SUBJECT: UNIVERSITY OF MARYLAND - REQUEST FOR ADDITIONAL
INFORMATION RE: FOR THE RENEWAL OF FACILITY OPERATING LICENSE NO. R-
70 THE MARYLAND UNIVERSITY TRAINING REACTOR DOCKET NO. 50-166

Enclosed please find the responses to RAIs #1, 2, 4, 29, 31, 40, 44, 58-61 dated July 28, 2016 for
the University of Maryland Training Reactor (MUTR).

Technical Specifications

License No. R-70, Docket No. 50-166

Figure 6.1: Position Chart

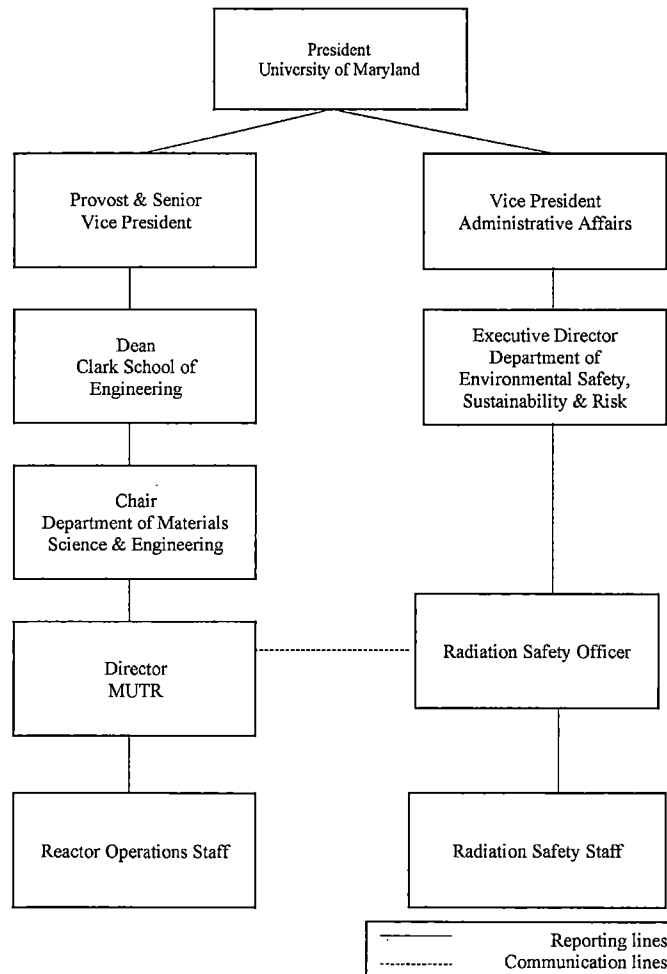
- 44. Revise TS 6.1.1, Figure 1 to clarify the current name for the Department of Environmental Safety, or justify why no change is necessary.

The figure has been revised to reflect the current name for the Department of Environmental, Safety, Sustainability and Risk.
